ADDENDUM NUMBER 02

DATE: 3/8/2023

PROJECT: MHS West Gym Floor Replacement

PROJECT NUMBER: 22-1724

2 CAVEMAN LOGO
A9.0 1 1/2" = 1'-0"

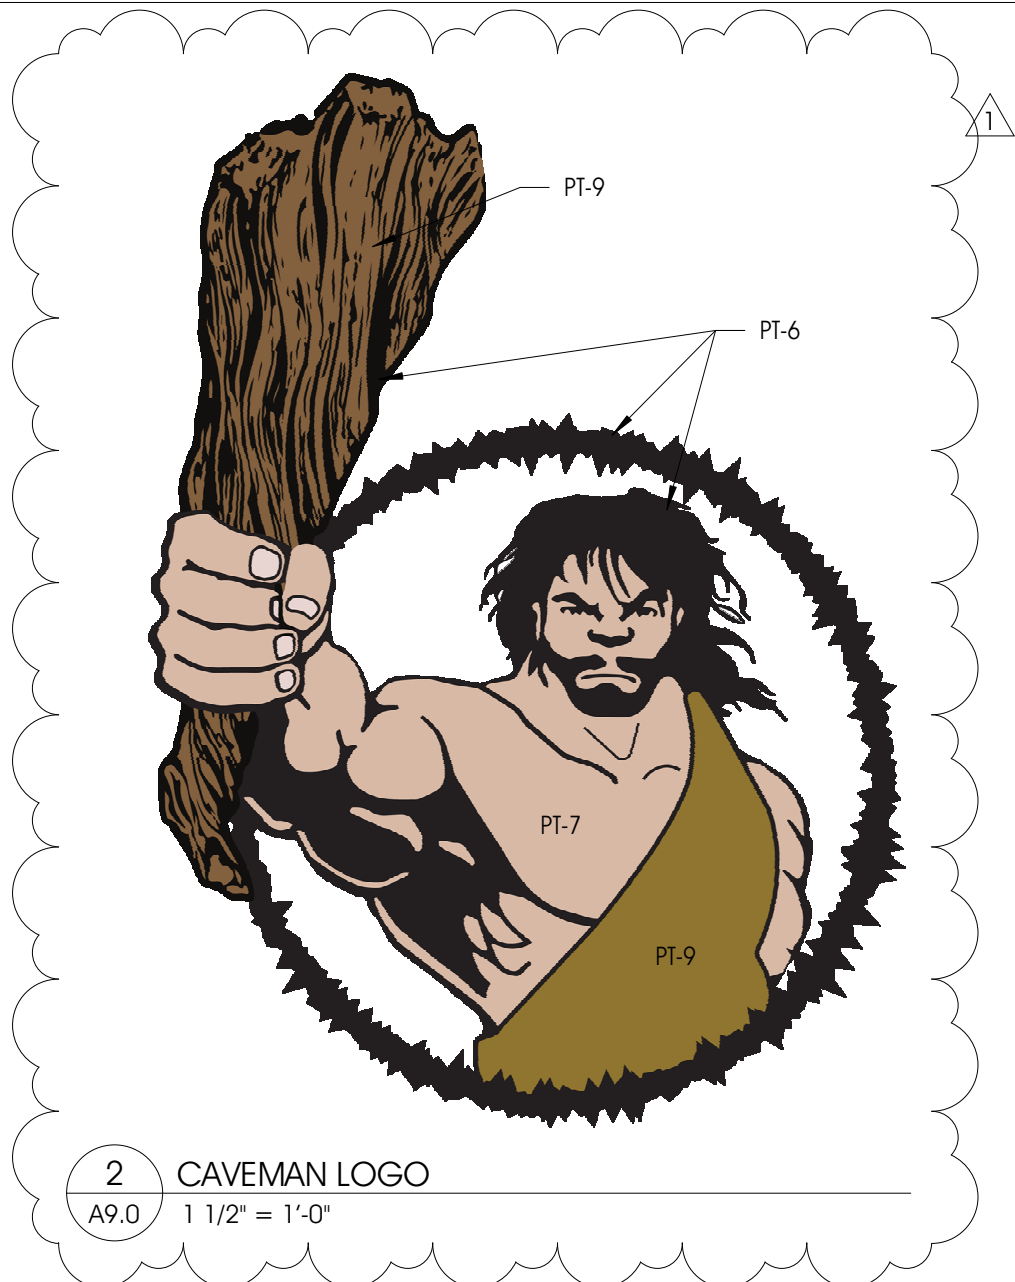
- 1) **ADD** Paint colors for Mishawaka Caveman logo to FINISHES LEGEND for paint stripe colors.
- 2) **ADD** Notes for paint clarification to GENERAL NOTES – FLOOR PLAN
- 3) **ADD** Caveman logo detail to sheet A9.0 for clarification on paint layout.

1 FINISH PLAN - LOWER LEVEL
A9.0 1/8" = 1'-0"

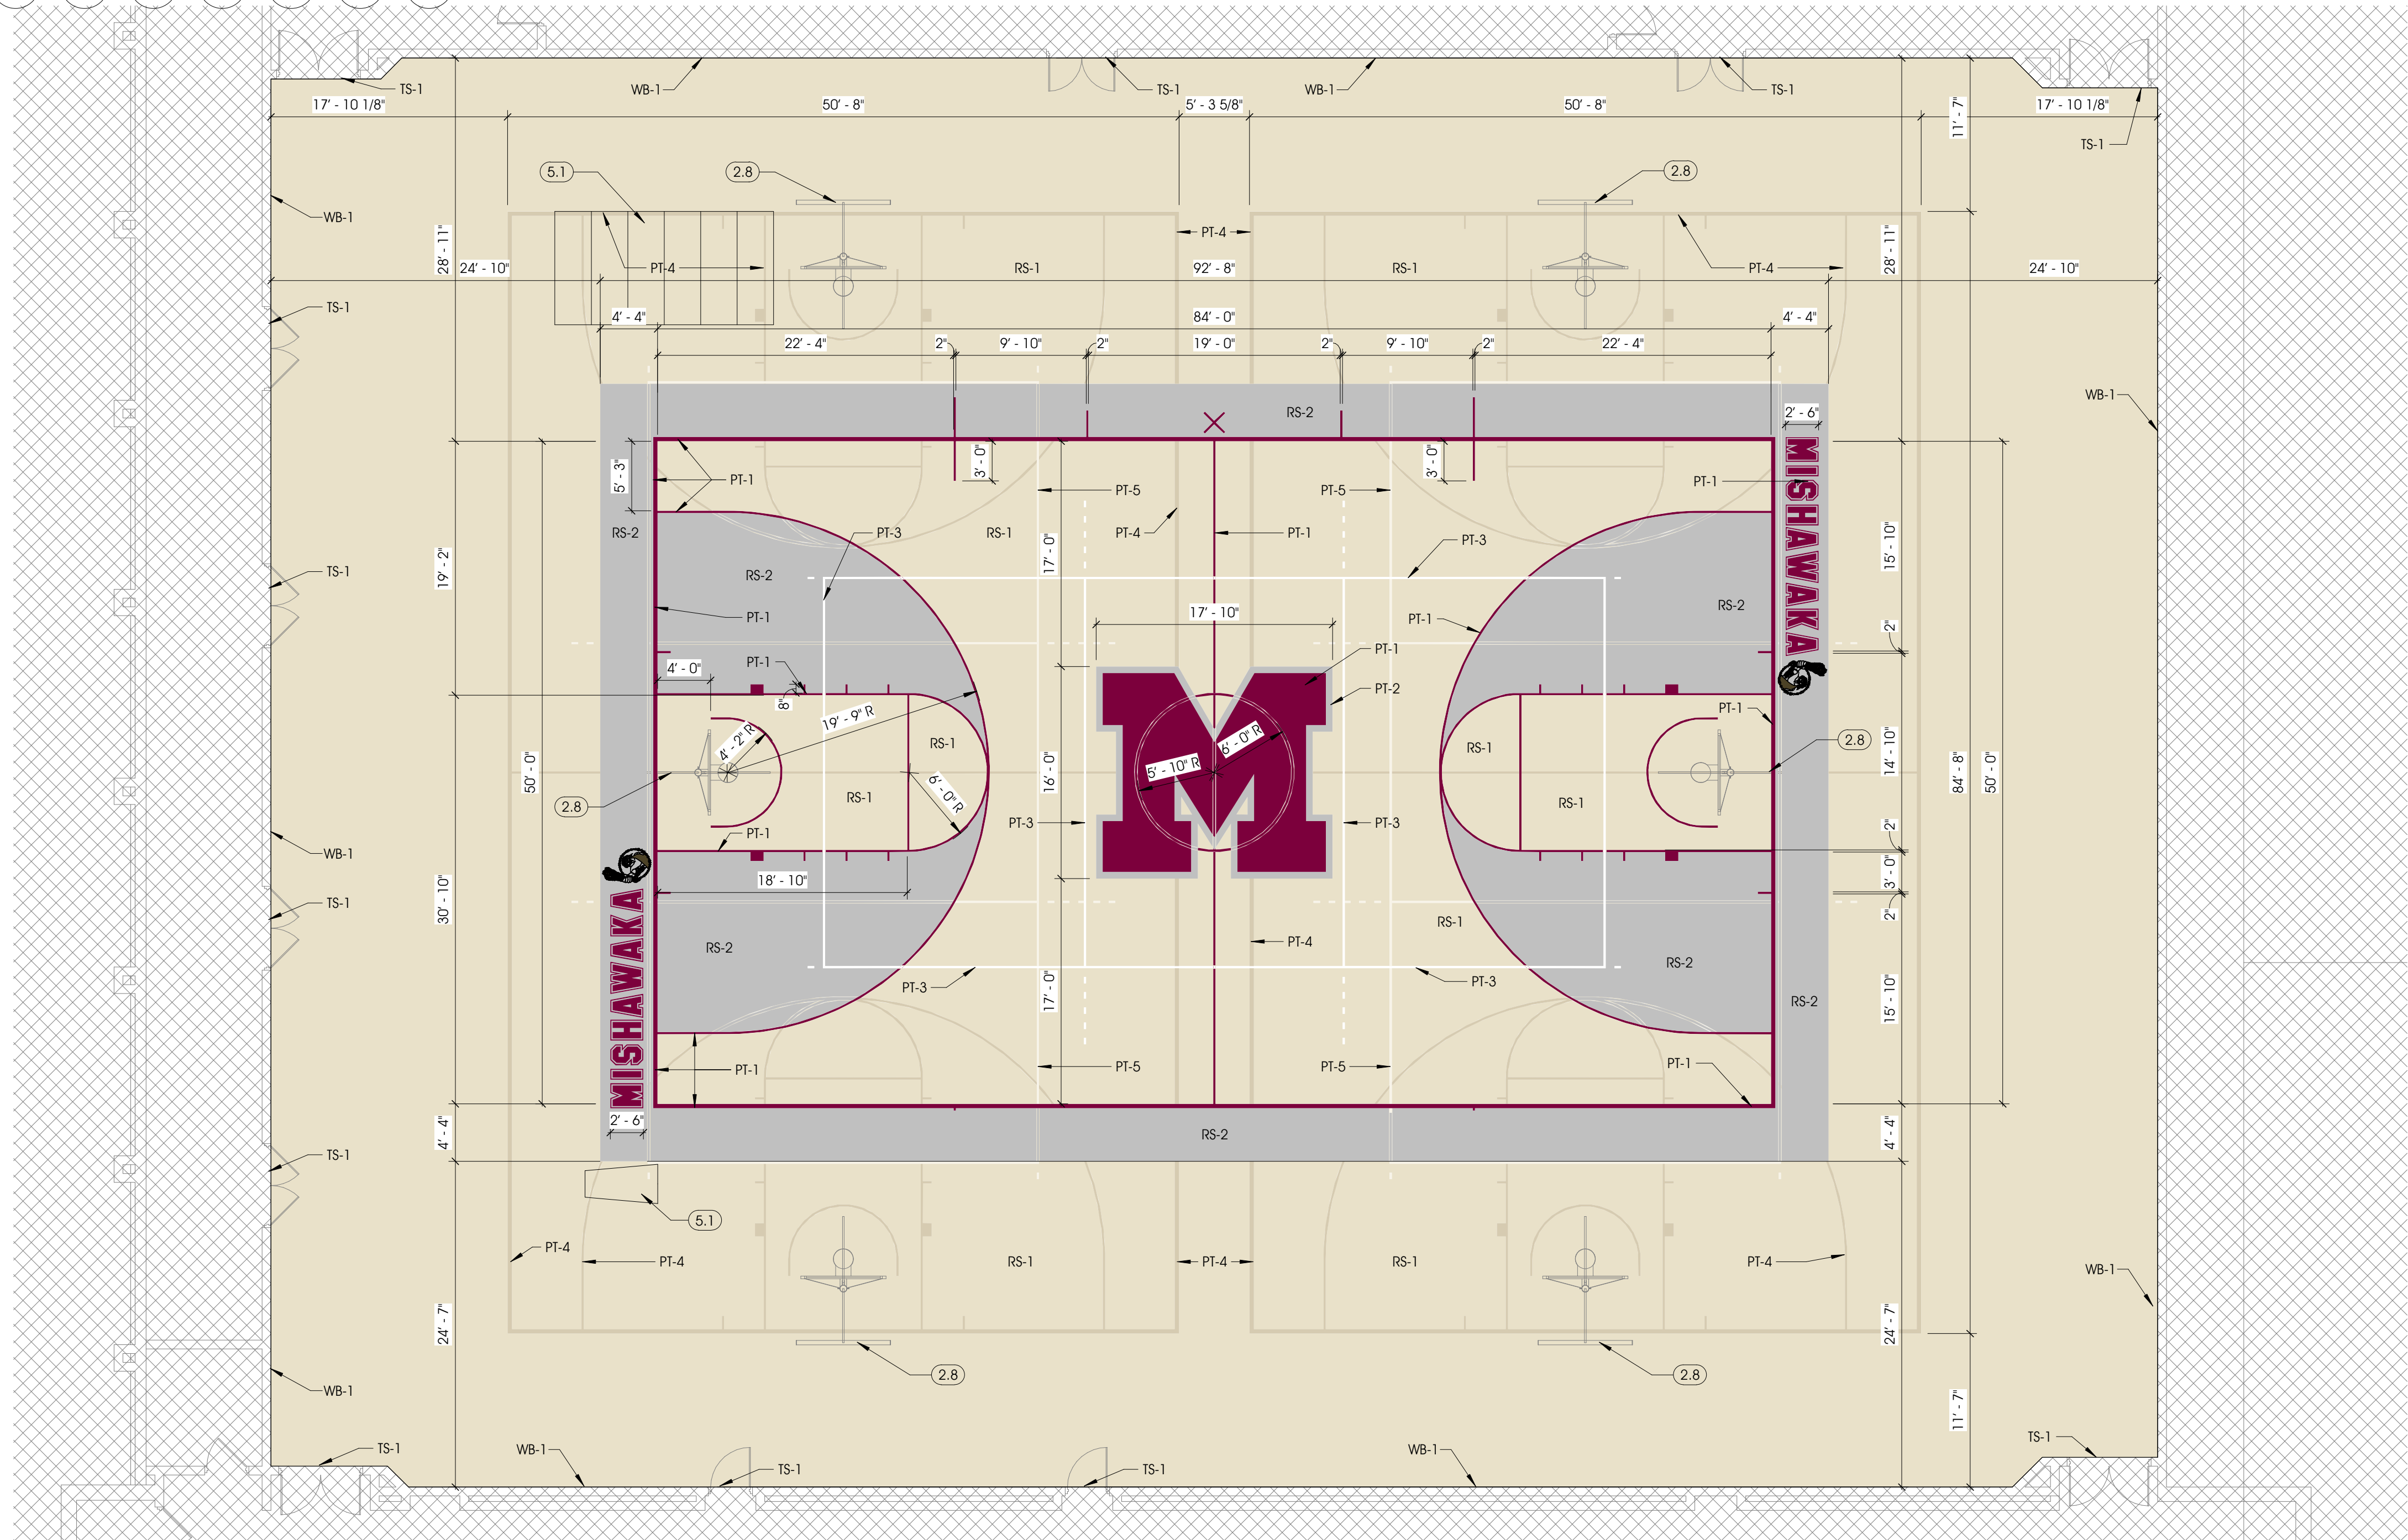
DRAWING A9.0 – LOWER LEVEL – FINISH PLAN

1 FINISH PLAN - FIRST FLOOR
A9.1 1/8" = 1'-0"

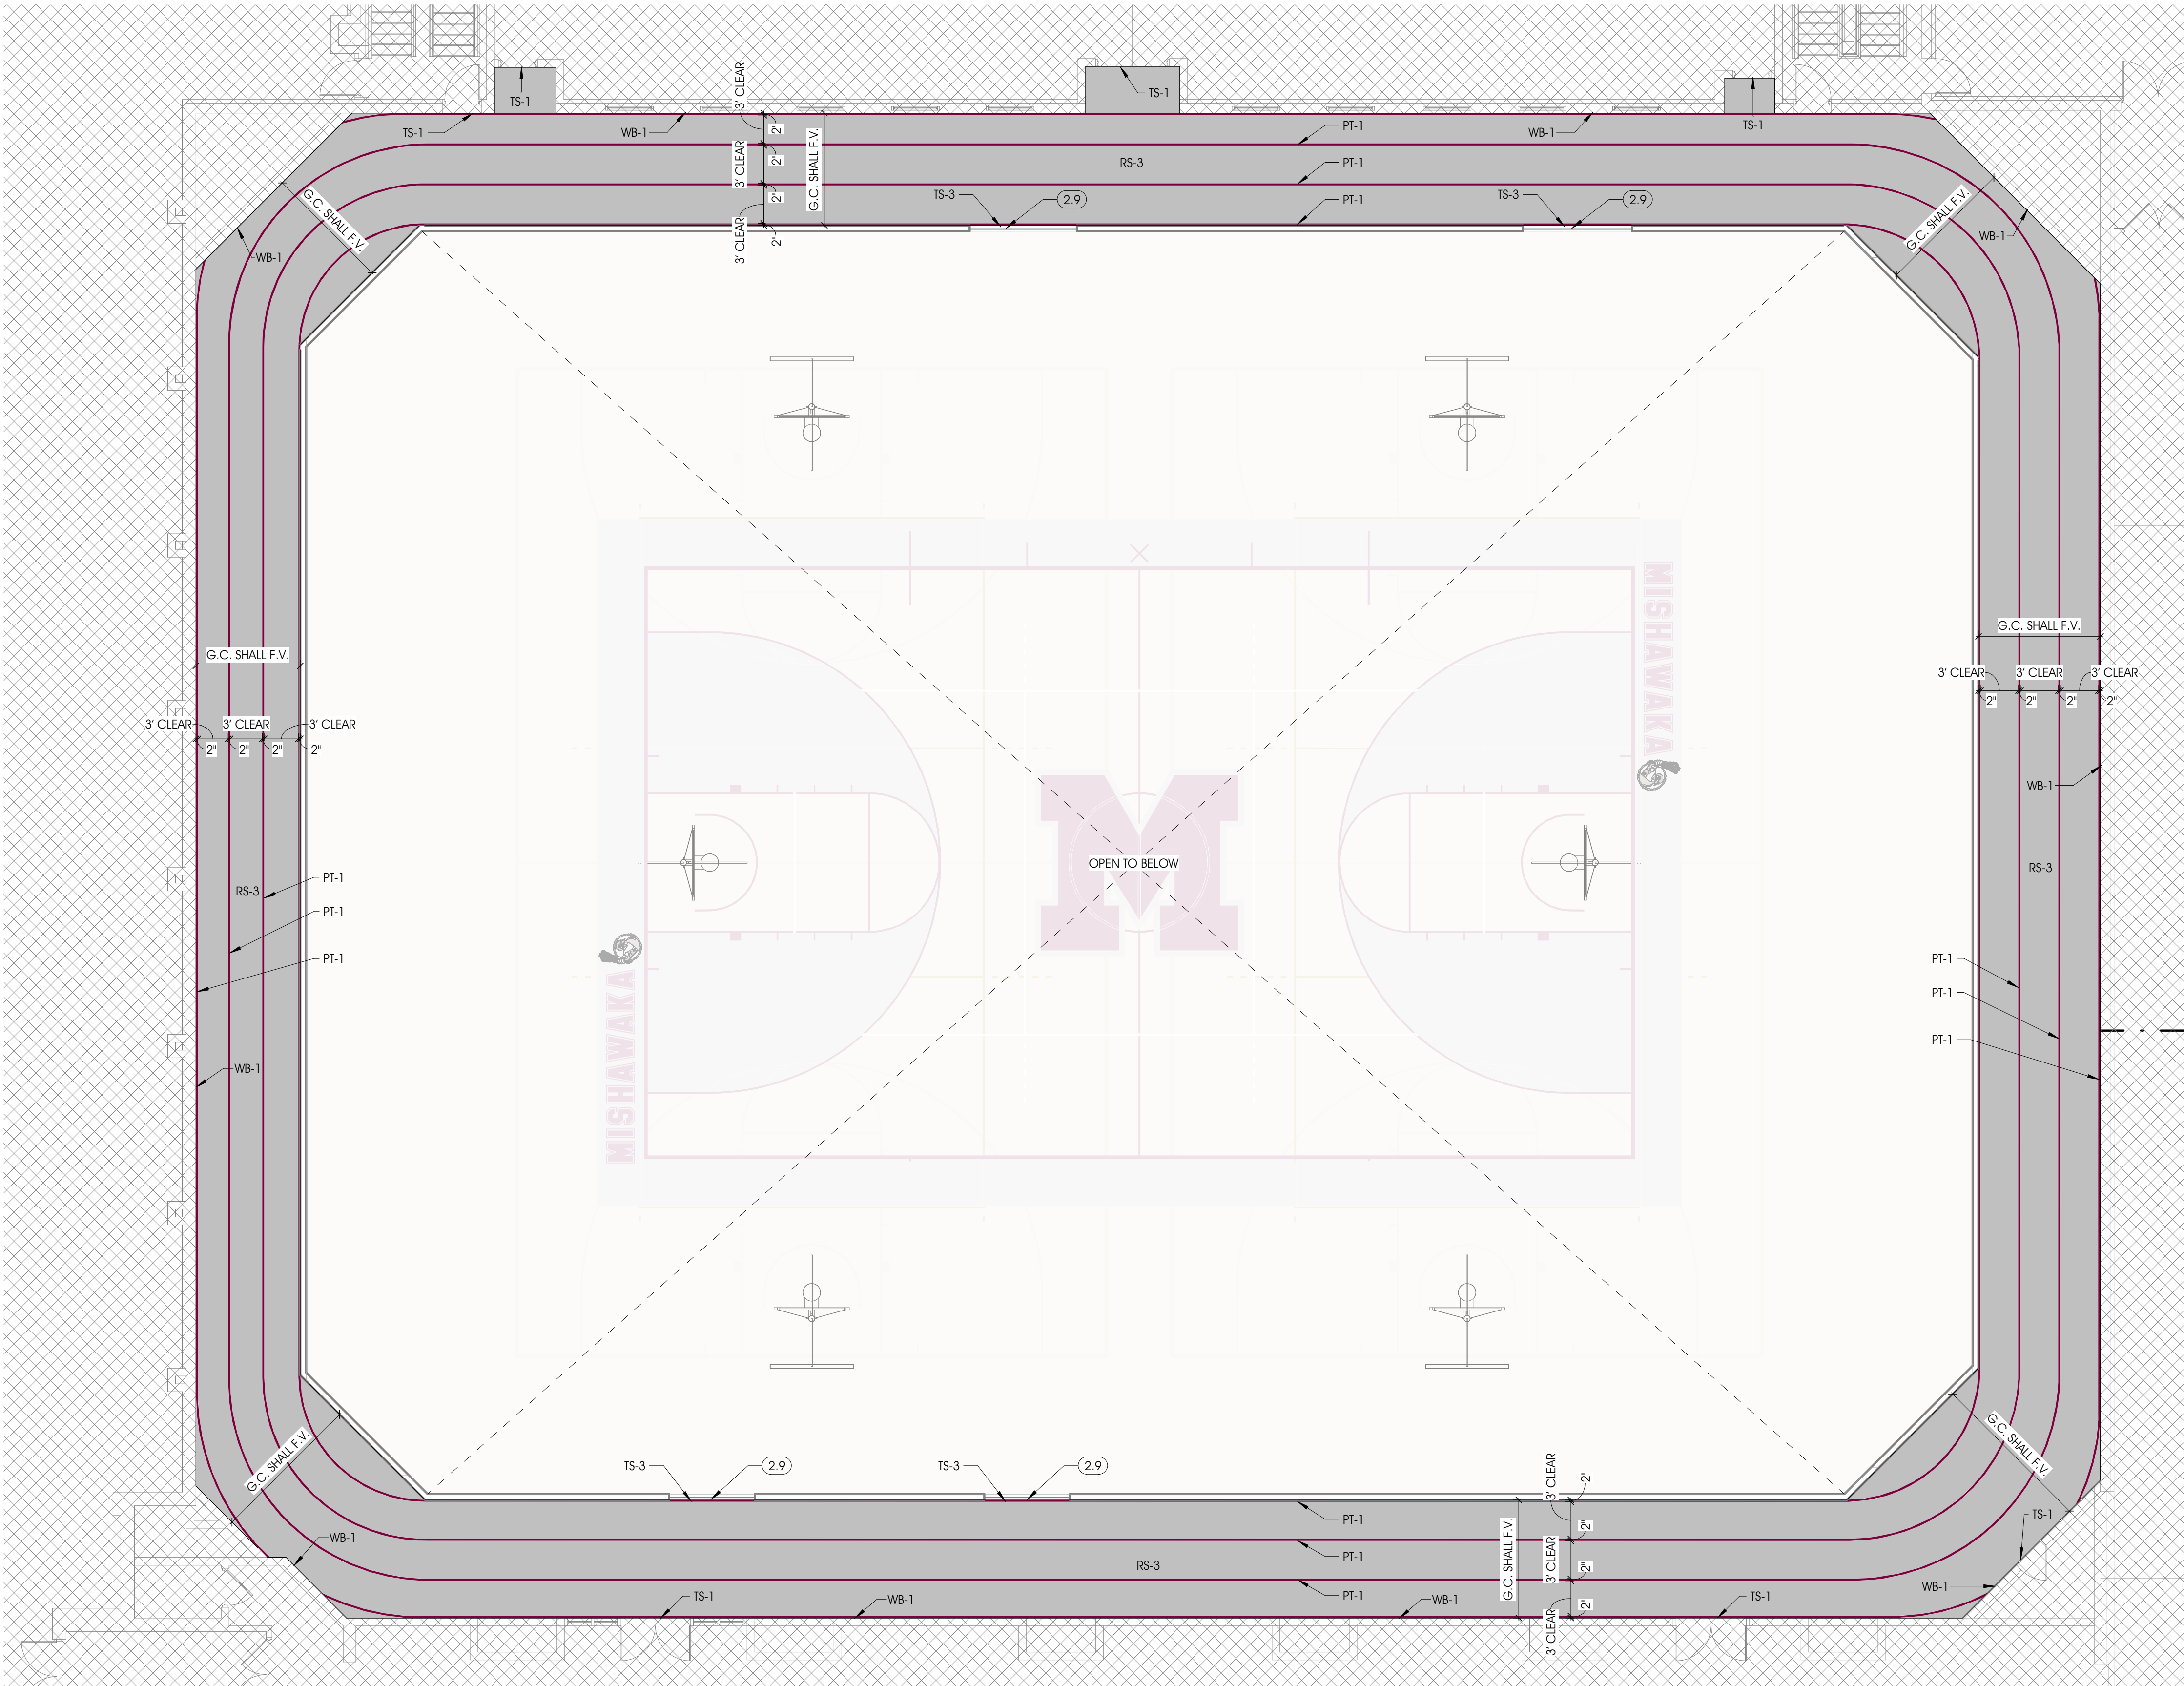
DRAWING A9.1 – FIRST FLOOR – FINISH PLAN

- 1) **ADD** Notes for paint clarification to GENERAL NOTES – FLOOR PLAN
